**BOROUGH OF PARK RIDGE
ZONING BOARD
MARCH 19, 2019
REGULAR MEETING MINUTES**

New Application
#ZBA 19-02
Park Ridge Diner Corporation
125 Kinderkamack Road
127 Park Avenue
B1
Block 1805 / Lot 8 & 9
Site Plan / Use Variance / Shared Parking

To: Borough of Park Ridge Zoning Board of Adjustment
From: Joseph H. Burgis, PP, AICP & Thomas Behrens, Jr., PP, AICP
Subject: Park Ridge Diner Corp.
125 Kinderkamack Road & 127 Park Avenue
Block 1805 Lots 8 & 9
Amended Site Plan Approval & 'c' Variance Request
Date: February 11, 2019
BA#: 3563.04

RE: Amended Preliminary/Final Site Plan Review

4'10" HI X 7' DIA. HEAVY DUTY SEEPAGE PIT
(AS BUILT BY PEERLESS)

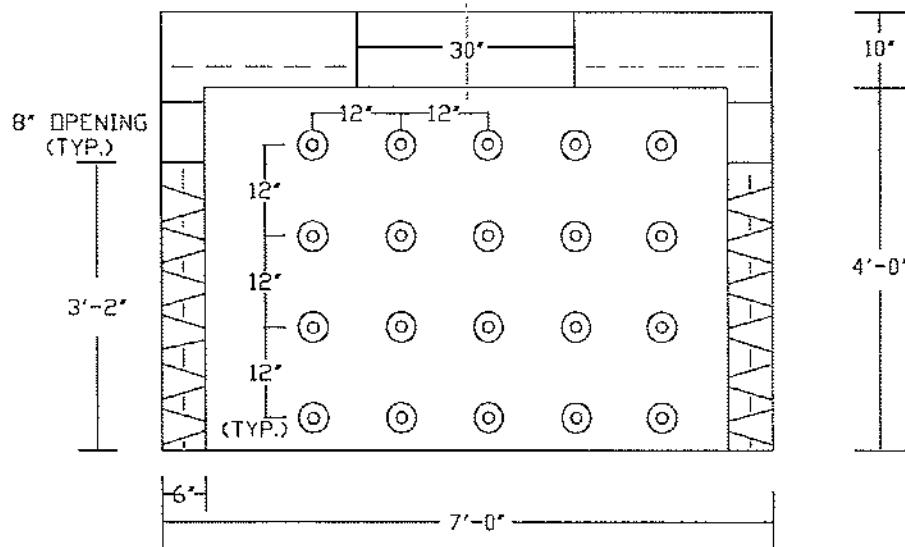
- e. The Applicant shall revise the Seepage Pit Detail to indicate the entire structure and its components as being HS-20 load rated.
 - f. A stormwater operations and maintenance manual shall be provided for the proposed seepage pit addressing stormwater operations and maintenance both during construction and going forward after project completion.

- e. The Applicant shall revise the Seepage Pit Detail to indicate the entire structure and its components as being HS-20 load rated. **This comment has been addressed. No further action required.**
